## 8.7 Individual(s) Comments and Responses

**DEIR/DEIS, MONTEREY PENINSULA WATER SUPPLY PROJECT**  
**PUBLIC COMMENT BEECH-2**

**PUBLIC COMMENT BEECH-3**

**PUBLIC COMMENT BEECH-4**

SITE PLAN SW-2

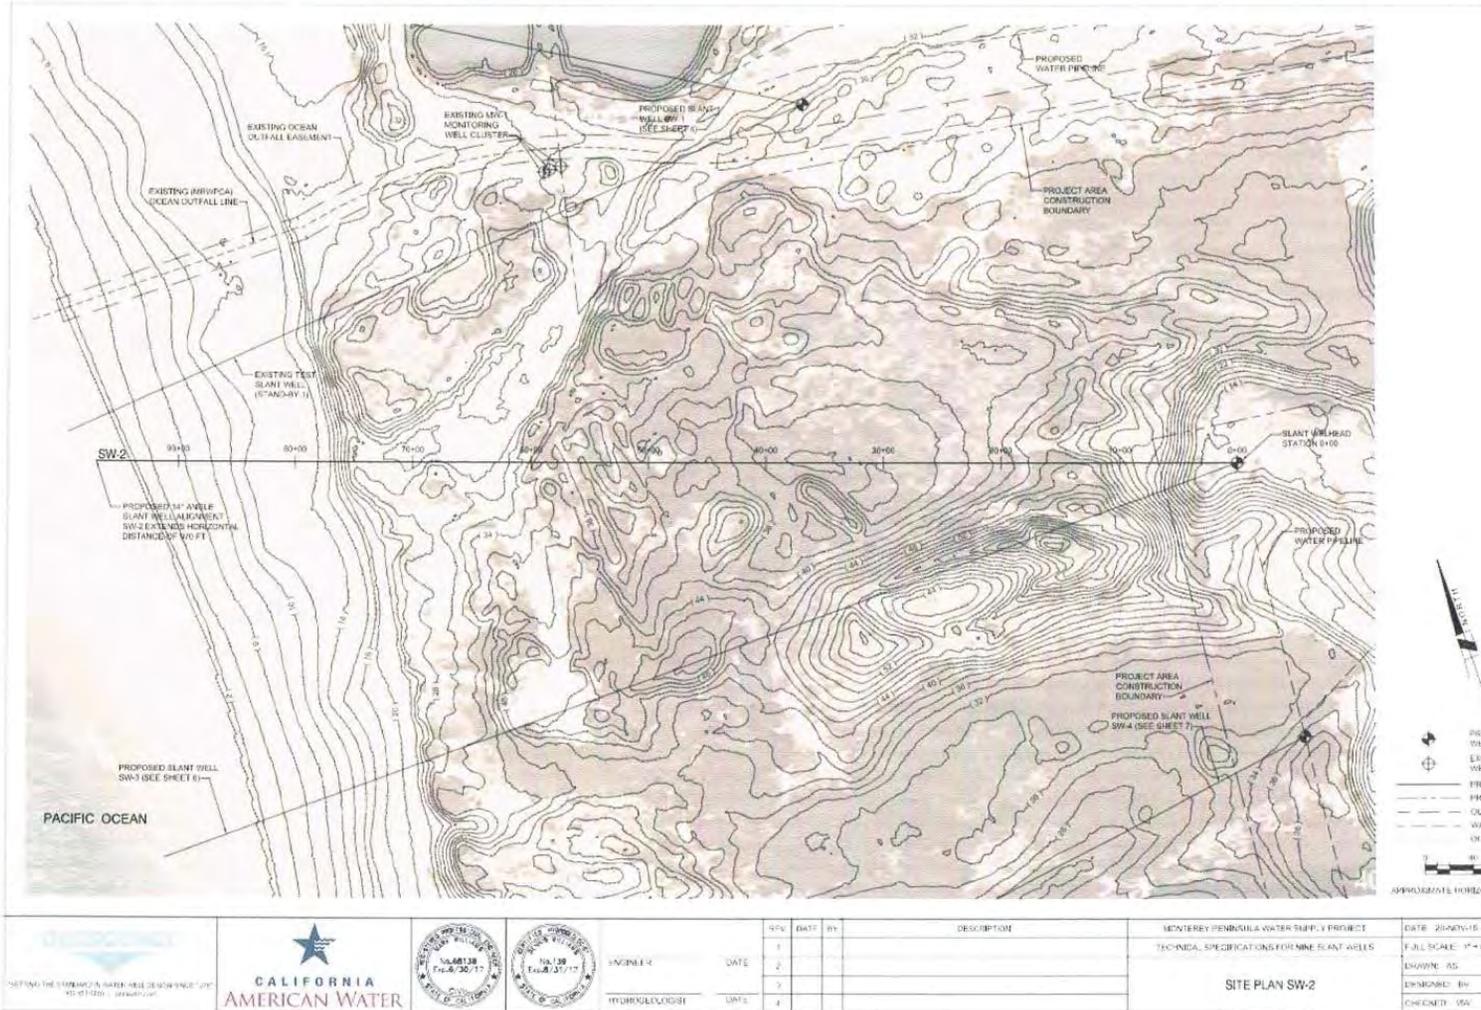
Cal-Am has subsequently issued an RFP for construction of the production wells (ahead of approval of the test results), where the test well was explicitly allowed to be “converted into a production well.” A bid from Boart Longyear was accepted, including use of the test well as a backup well in the production system. The map below is taken from the official documentation of the project at <http://www.watersupply.org> under

PROCUREMENT, 1. Source Water Slant Wells RFP, Contract Drawings. The converted test well is seen slanting down from top center, labelled EXISTING TEST SLANT WELL (STAND-BY 1).

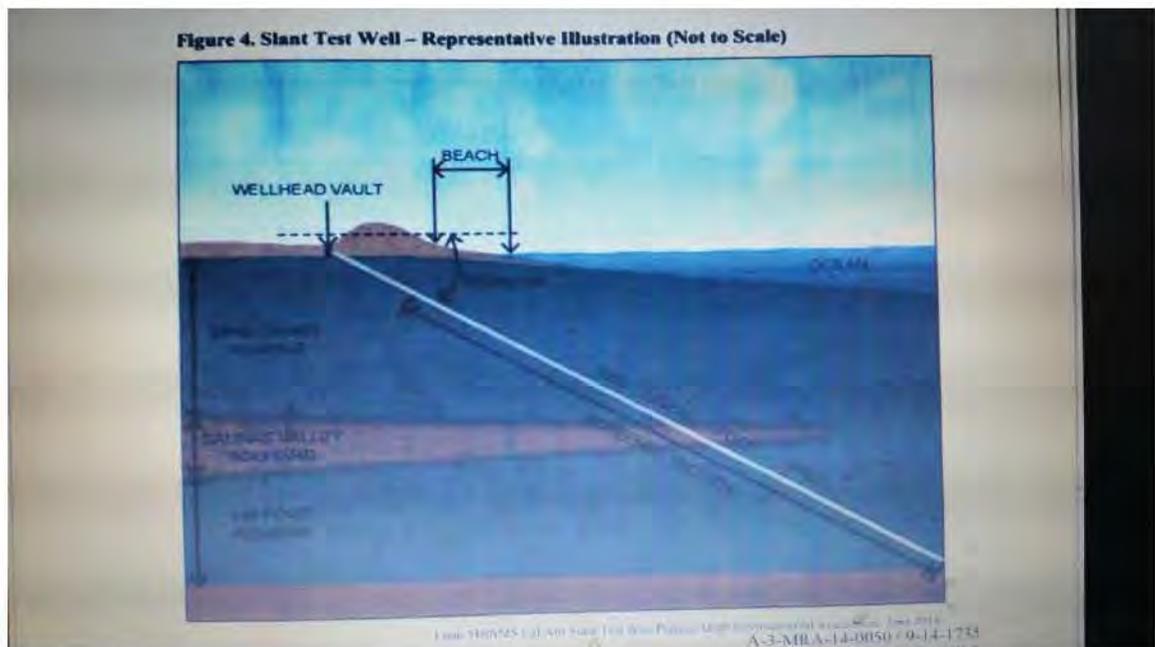
The first illustration I encountered was Exhibit 3 of the package that Commissioners would have seen in deciding the Appeal and granting the test well permit in November 2014.

This gives an immediate impression that the well extends way under the OCEAN as it says (barely legibly, even in the original – see <http://documents.coastal.ca.gov/reports/2014/11/W14a-s-11-2014.pdf>). This illustration, besides being “Not to Scale”, was not kept up to date with the text of the permit, so it says along the well bore “1000 LINEAL FEET”, and, given the position of the original WELLHEAD VAULT at 450 feet inland from mean sea level, the well length is exaggerated to look as though it is over 2000 feet. This would not matter so much were it not for the fact that most of the Coastal

Commissioners, with their almost impossible reading load, would have formed their main impression from this picture. Probably most CalAm customers still think this is roughly the slant well that is being tested – it was only a few months ago that I personally began to discover that it was not.

EXHIBIT 2

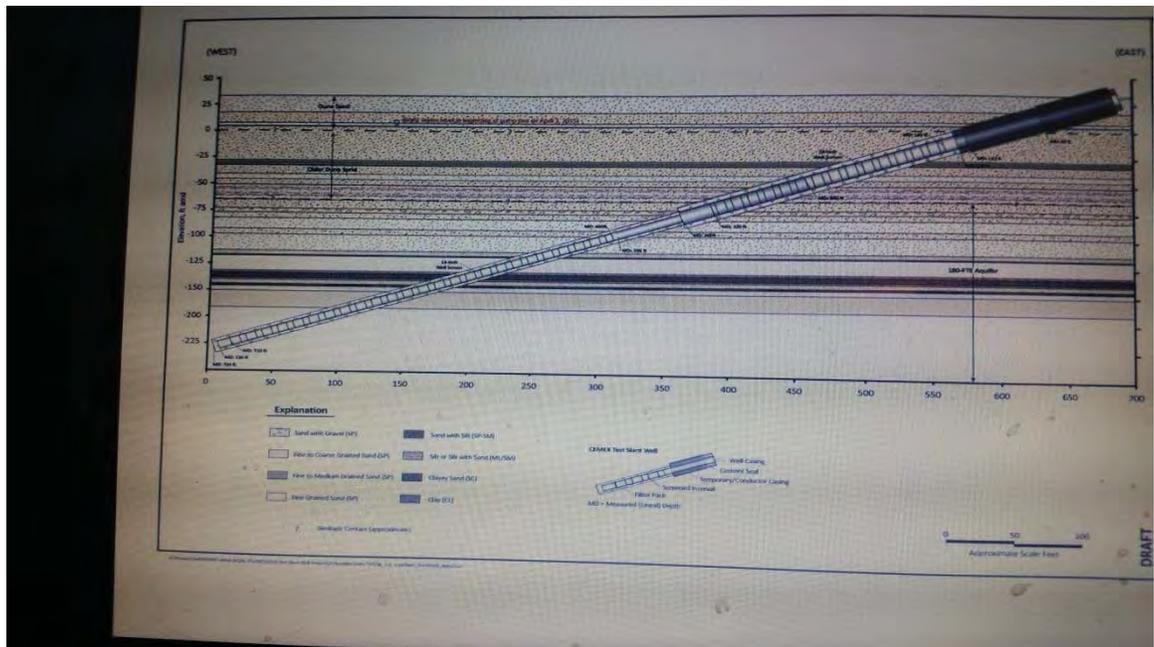
Seen in cross-section, the actual test well is shown below:

Note that the horizontal length of the well is shown as less than 700 feet, consistent with the following calculation:

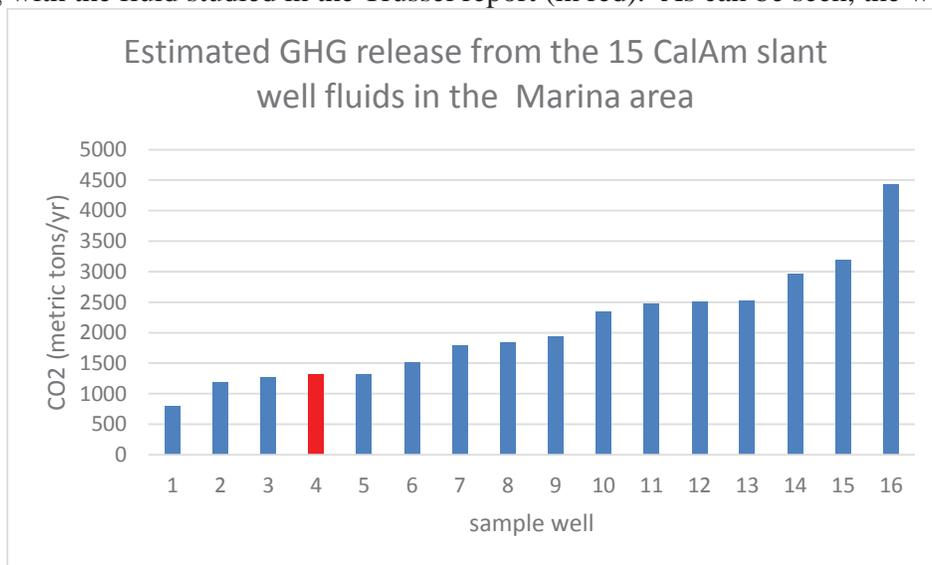
- In the Trussel report the well fluid composition used to compute the “worst-case” carbon dioxide release is not representative of fluids sampled to date and in fact is nearly the “best-case” scenario

The well fluid composition used in the Trussel report to compute carbon dioxide release is not representative of the carbon dioxide gas contents of the 15 wells sampled to date in the Marina area as part of the CalAm project. Figure 1 below shows my estimated carbon dioxide release rates along with the fluid studied in the Trussel report (in red). As can be seen, the well fluid

**Figure 3 Time for Slant Well to Pull 96% Seawater (GeoScience 2014b).**

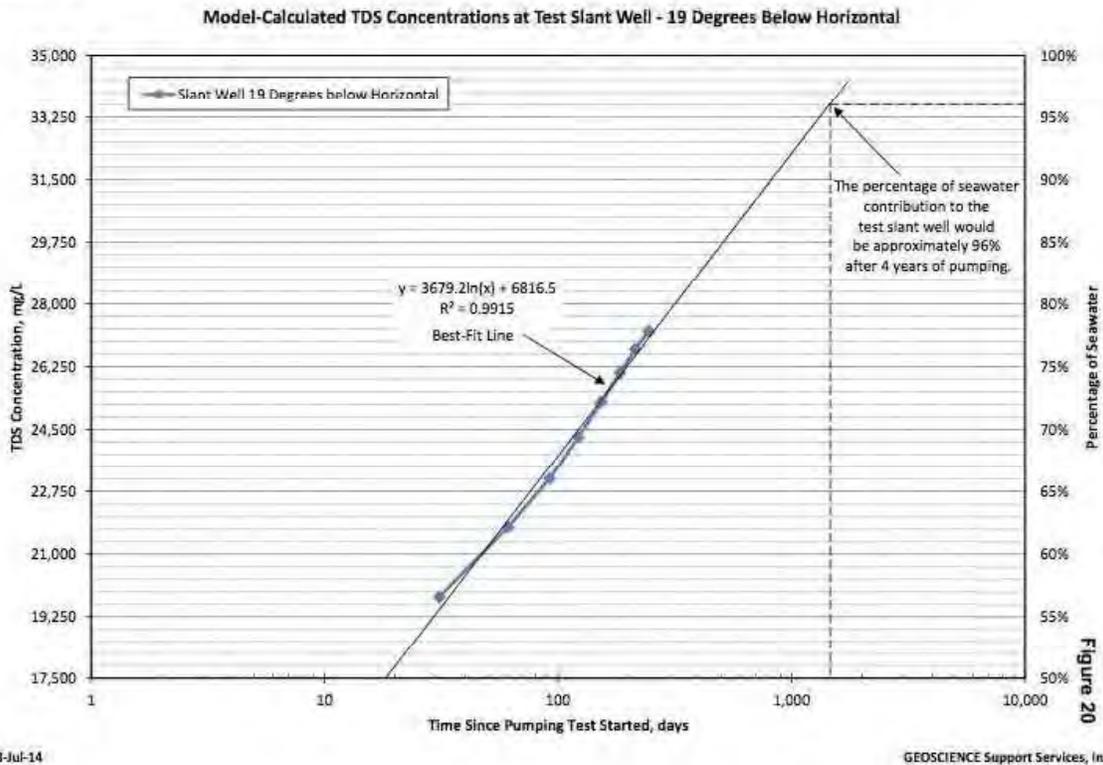
4. Further evidence that the test slant well has caused seawater intrusion into the 180/400 Sub-basin is provided by Figure 3 below, extracted from the GeoScience 2014b report in the appendices to the DEIR/DEIS.

5. The DEIR/DEIS has therefore proven that the operation of the test slant well has harmed the 180/400 Sub-basin by inducing more seawater intrusion into this sub-basin.
6. The DEIR/DEIR should have made this highly significant environmental impact (the increase in seawater intrusion caused by the pumping of the test slant well) far clearer, more prominent and in the main body of the DEIR/DEIS document rather than burying this information in the Appendices and a buried reference to a website.
7. The DEIR/DEIS states that, "Developed waters are available for use by the party who develops them, subject to the "no injury" standard discussed previously." Increasing seawater intrusion into a critically overdrafted sub-basin is a form of environmental injury.

Moore-2 Figure 3 from Geoscience 2014b, as cited in EIR/EIS Appendix G2, presents modeled results of the anticipated salinity at the test slant well over time and therefore in the capture zone; it does not illustrate observed results of the test slant well, nor does it provide evidence of increased seawater intrusion. The graph shows how many days are expected to elapse, from the start of pumping, before the test slant well would capture 96 percent seawater. It is not accurate to consider this evidence of seawater intrusion in the 180 and 400-Foot Aquifers. In addition, the test well was not operating until 2015, after the release of the referenced Geoscience 2014 report. As stated in response to comment Moore-1, as the highly brackish, ambient groundwater would be extracted by the slant wells, seawater would recharge the capture zone and the percentage of seawater would increase. The slant wells would capture seawater that would otherwise flow inland, thereby reducing the potential for seawater intrusion inland of the capture zone. See Master Response 8, Section 8.2.8.1 for a description of the hydrogeologic characteristics of the feedwater capture zone. No significant impact on groundwater quality has been observed as a result of test slant well operation.
